**Planning Department
Transportation Development Services**

**Re: A Façade Renovation
111 Cardenas NE
Traffic Circulation Layout
Engineer's/Architect's Stamp dated 10-22-15 (K18-D106)**

**Re: A Façade Renovation
111 Cardenas NE
Traffic Circulation Layout**
Engineer's/Architect's Stamp dated 10-9-15 (K18-D106)

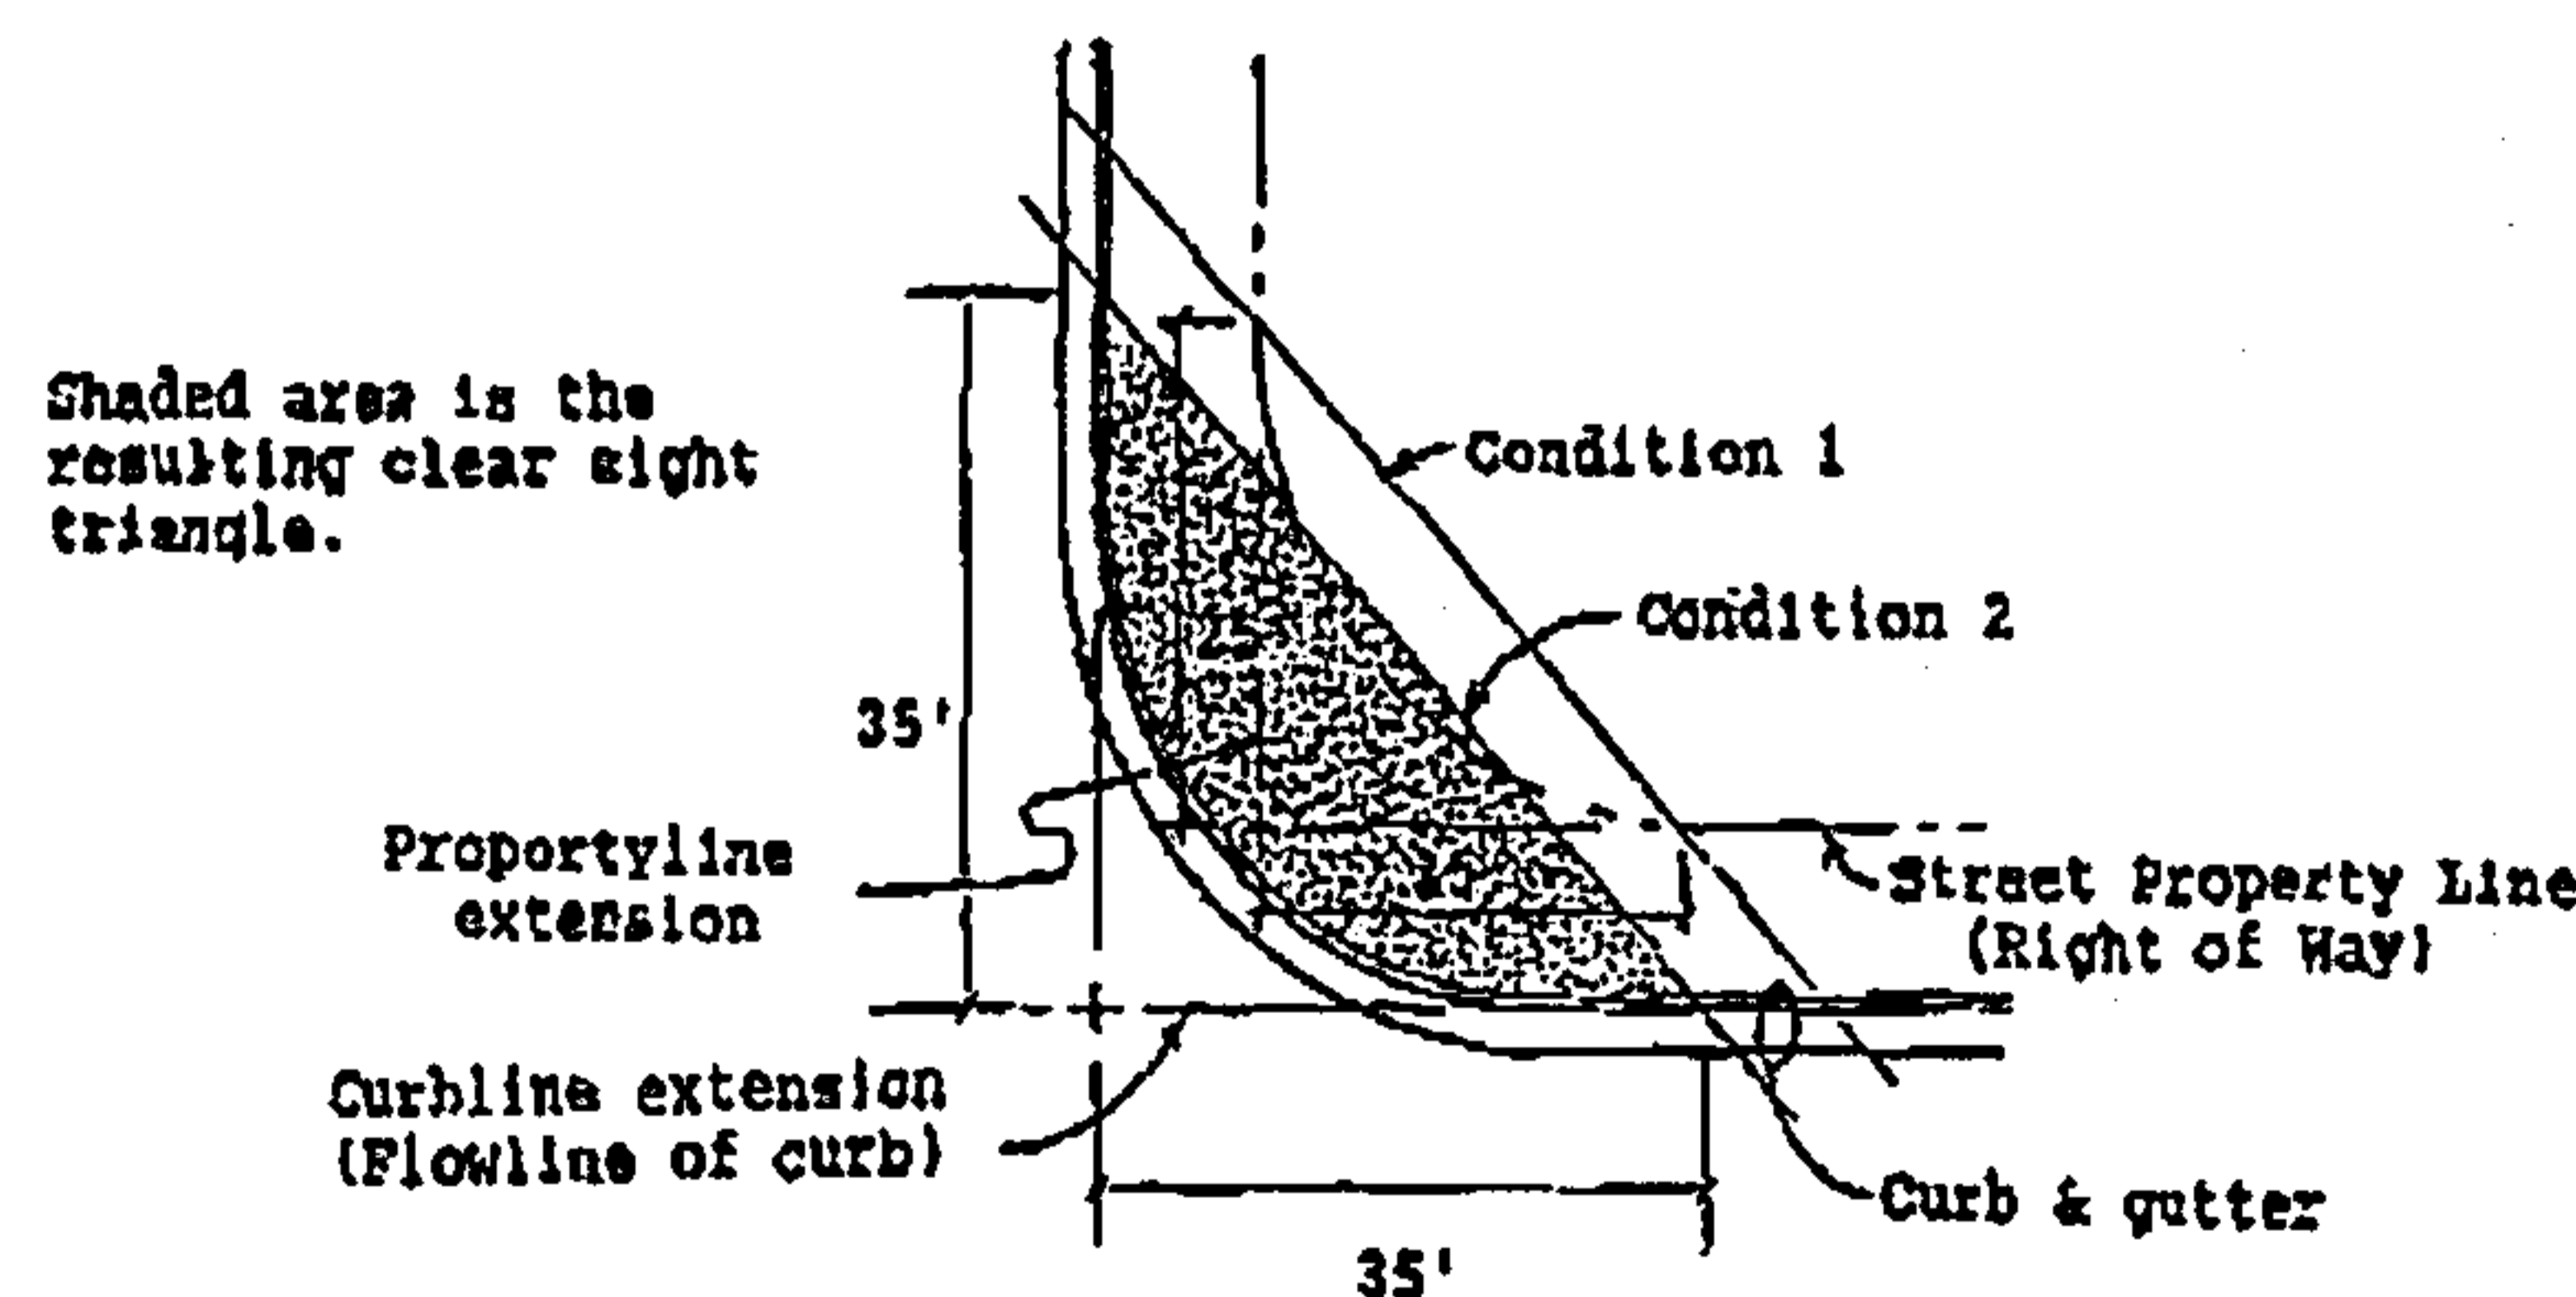
1. Please show a vicinity map showing the location of the development in relation to streets and well known landmarks.
2. List the number of parking spaces required by the zoning code, as well as the proposed number of parking spaces.

3. Clarify the extents of the current phase.
4. Please identify all existing electrical and light poles that influence the parking and circulation on the site.

5. Identify all existing access easements and rights of way with dimensions.
6. Identify the right of way width, medians, curb cuts, and street widths on Cardenas Dr.

7. Please list the width and length for all parking spaces. Identify the distance between all angled parking spaces. Per DPM, there must be an 11 ft. drive isle between angled parking spaces.

8. The ADA accessible parking sign must have the required language per 66-7-352.4C NMSA 1978 **"Violators Are Subject to a Fine and/or Towing."** Please show a detail of this signage.

9. The ADA access aisle shall have the words **"NO PARKING"** in capital letters, each of which shall be at least one foot high and at least two inches wide, placed at the rear of the parking space so as to be close to where an adjacent vehicle's rear tire would be placed. (66-1-4.1.B NMSA 1978)

10. Show all drive aisle widths and radii.

11. List radii for all curves shown; for passenger vehicles, the minimum end island radius is 15 feet. Landscape island radius for delivery trucks, fire trucks, etc. is 25 feet or larger

12. Per the DPM, a 6 ft. wide ADA accessible pedestrian pathway is required from the public sidewalk to the building entrances. Please clearly show this pathway and provide details.

13. Per the DPM, a 6 ft. wide ADA accessible pedestrian pathway is required from the HC parking stall access aisles to the building entrances. Please clearly show this pathway and provide details.

14. Provide a min 6" or max 8" high concrete barrier curb or other acceptable barrier between landscaping and parking areas and/or drive aisles.
15. Design delivery vehicle route needs to be shown.

16. Service vehicle and/or refuse vehicle maneuvering must be contained on-site; provide a copy of refuse approval.
17. It is not apparent what type of pavement surface is being proposed. A hard driving surface will be required as part of this proposed project for parking area and drive aisles. The drawing states that there is "existing earth", please clarify detail.

18. Please clarify how the site meets clear sight triangle requirements.
19. Please provide a sight distance exhibit (see the *Development Process Manual, Chapter 23, Section 3, Part D.5 Intersection Sight Distance*). Please provide this detail on Cardenas Dr.

20. Please add the following note to the clear sight triangle: "Landscaping and signage will not interfere with clear sight requirements. Therefore, signs, walls, trees, and shrubbery between 3 and 8 feet tall (as measured from the gutter pan) will not be acceptable in this area."
21. Please include a copy of your shared access agreement with the adjacent property owner.

22. Unused curb cuts must be replaced with sidewalk and curb & gutter. A build note must be provided referring to the appropriate City Standard drawing.
23. Please include two copies of the traffic circulation layout at the next submittal.
